Cuerden Lancashire

WSP Transport Documentation Review

Client:	Brookhouse Group	Job No:	J3250954
Date:	24 November 2023	File Name:	TN08 v1.1
Prepared by:	LCW	Approved by:	ME

Figure 1.1 : Walking Routes

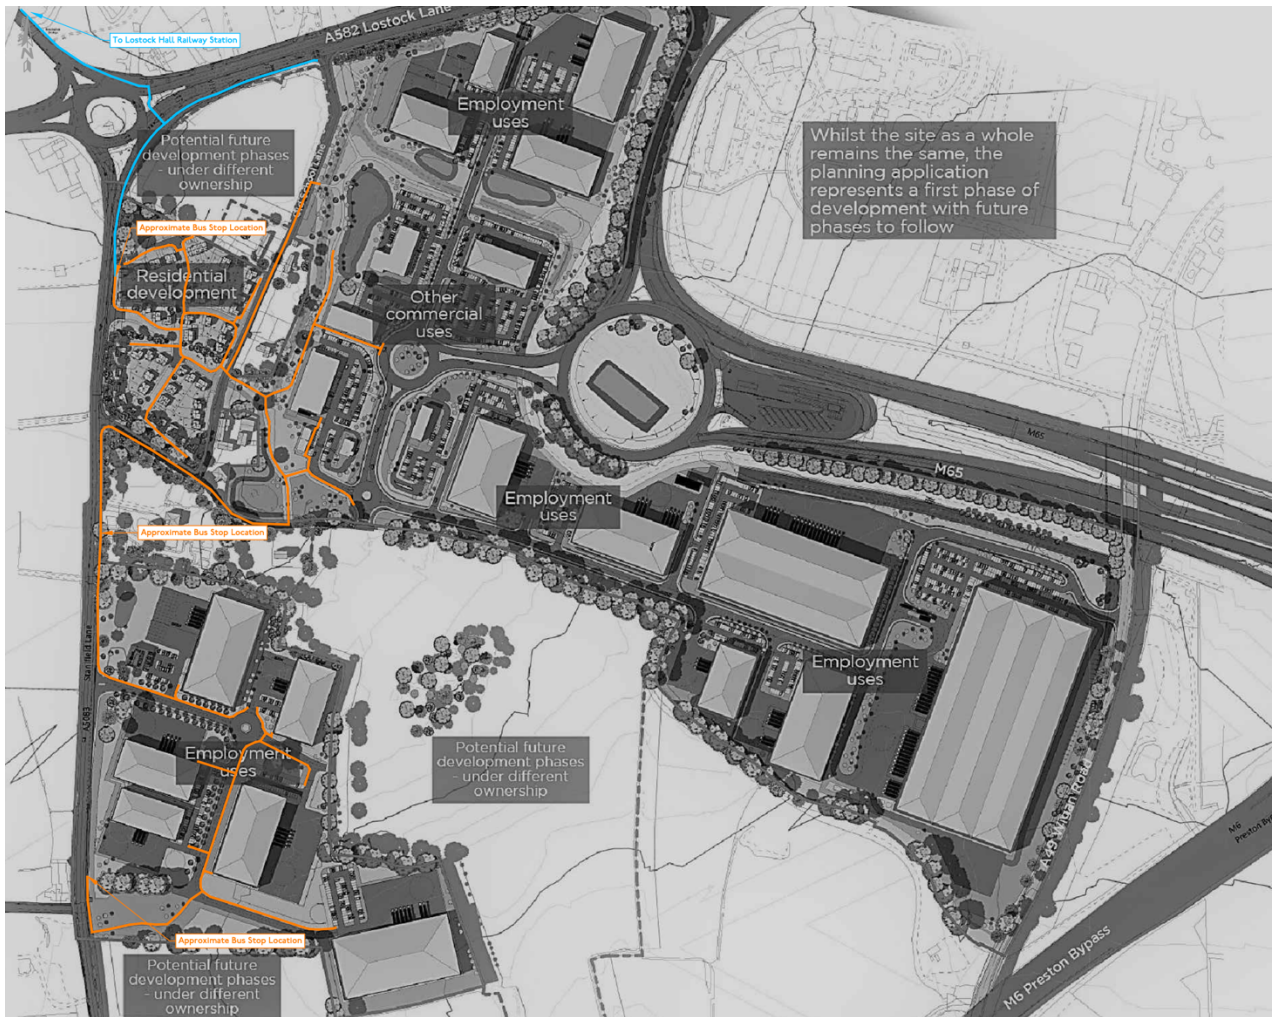
- 1.2.9 [Figure 1.1](#) shows the walking routes within the site which are within 400m of a bus stop and 800m of the railway station.

1.2.10 The plan shows that only a small area of the residential site is located within 800m of the railway station whilst much of Zone A is not within a suitable walking distance of a bus stop or the railway station.

1.2.11 The few areas within Zone A which are within walking distance of a bus stop are reliant on upgrades to Stoney Lane to provide direct links. As will be set out in more detail within this note, these improvements cannot be delivered to ensure that this area can be deemed to be sustainable development in accordance with the National Planning Policy Framework (NPPF).

Figure 1.2 : Stoney Lane Dimensions (based on Topographical Survey)

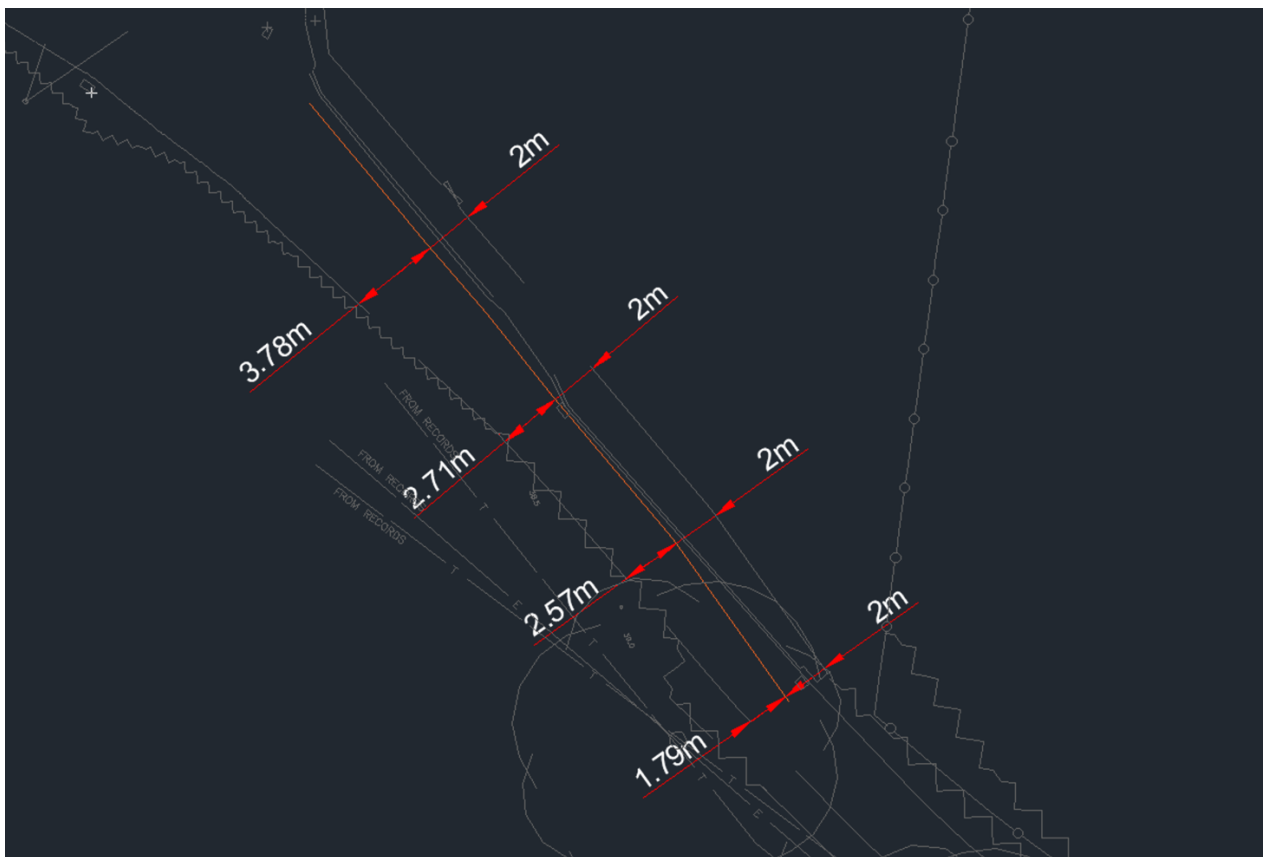
- 1.6.7 WSP drawing 84465-WSP-XX-DR-018 shows the introduction of a 2m footway along Stoney Lane to improve connectivity between the development and bus stops on Stanifield Lane. A connection is required to deliver a scheme which can be deemed accessible by sustainable modes of travel, and which therefore accords with the NPPF.

- 1.6.8 Alongside Elmar House there are sections of adopted verge which are only 1m wide where the carriageway is only 3m wide. The introduction of a 2m footway in this area could result in a remaining carriageway width of less than 2m.

- 1.6.9 WSP's plan has been drawn on OS mapping rather than the topographical survey which appears to show a wider verge to the north than is actually available.

- 1.6.10 In order to check the actual available carriageway widths if a 2m wide footway is introduced, topographical survey and land registry mapping along Stoney Lane has been used to take measurements. The results are shown in [Figure 1.2](#).

- 1.6.11 As can be seen in [Figure 1.2](#), the introduction of a 2m wide footway on Stoney Lane would result in inadequate carriageway widths (less than 2m at points) on Stoney Lane. This will result in the existing vehicular access rights being removed to the existing properties on Stoney Lane, the approved residential development for 9no. dwellings (app no. 07/2022/00886/OUT) and the Brookhouse land.
